Appl. No. 10/634,499
Amendment dated August 1, 2006
Reply to Office Action of March 2, 2006

Amendments to the Drawings:

FIGS. 4-5 of the present application (annotated - not to scale)

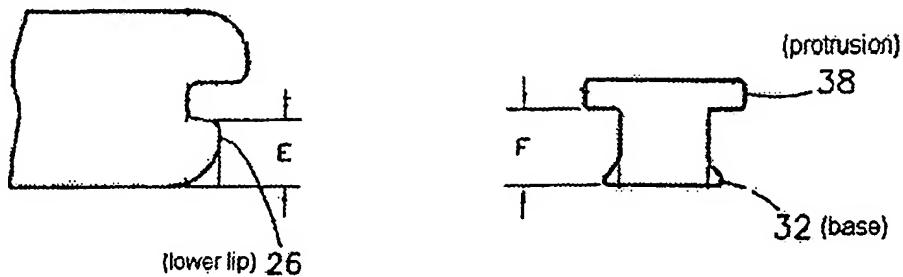
In the previous Amendment, Applicant argued that claims 28-36 were allowable because they included the feature of a board having a lower lip thickness "E" and a fastener having a protrusion with a height "F", wherein "E" is at least 1% greater than F. As also discussed in the previous Amendment, due to the lower lip being operable to fit under the protrusion despite being larger in size ($E > F$), the boards are more securely held by the fasteners, preferably with a downward holding force, than if the lower lip thickness was equal to or less than the protrusion height ($E < F$).

By way of this amendment, all independent claims now generally recite that the thickness of the lower lip is at least 1% greater than "the average vertical distance from the base to the protrusion." By reciting "the average vertical distance from the base to the protrusion" instead of only "height", the claims of the present invention are now more clearly differentiated from West. In particular, as demonstrated by the below figures, the thickness of West's lower lip is substantially *less* than the average vertical distance from the base to the protrusion provided by West's fastener.

FIG. 1A of West (annotated)

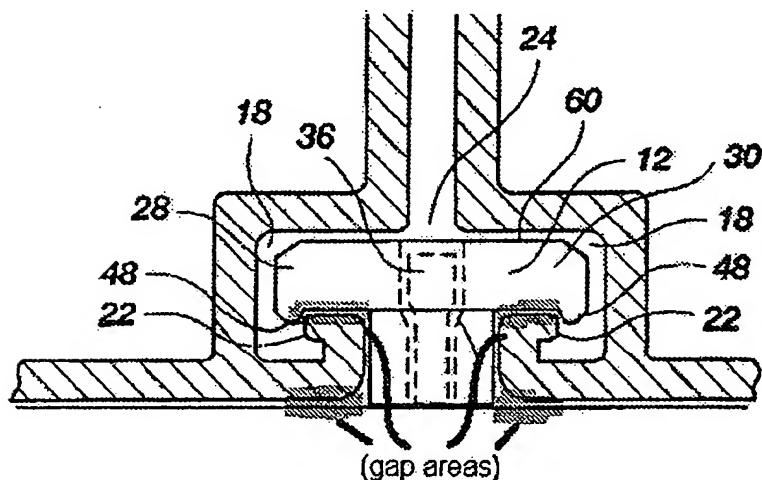
As can be seen from the above figures, the lower lip thickness provided by West is substantially less than the average height of its protrusion. As is evidenced by the gap areas highlighted above, West's lower lip thickness is substantially less than the protrusion height at all areas except those between the nub (48) and the lip edge (22). Further, the size of the nub (48) is minimal compared to the areas of the protrusion lacking the nub (48), thereby rendering the thickness of West's lower lip substantially *less* than the average vertical distance from the fastener base to the fastener protrusion. In contrast, the present application discloses and now claims a lower lip

thickness being at least 1% greater than the average vertical distance from the fastener base to the fastener protrusion. Such a configuration facilitates the securement of boards to joists and the application of the downward holding force discussed at length in the specification.
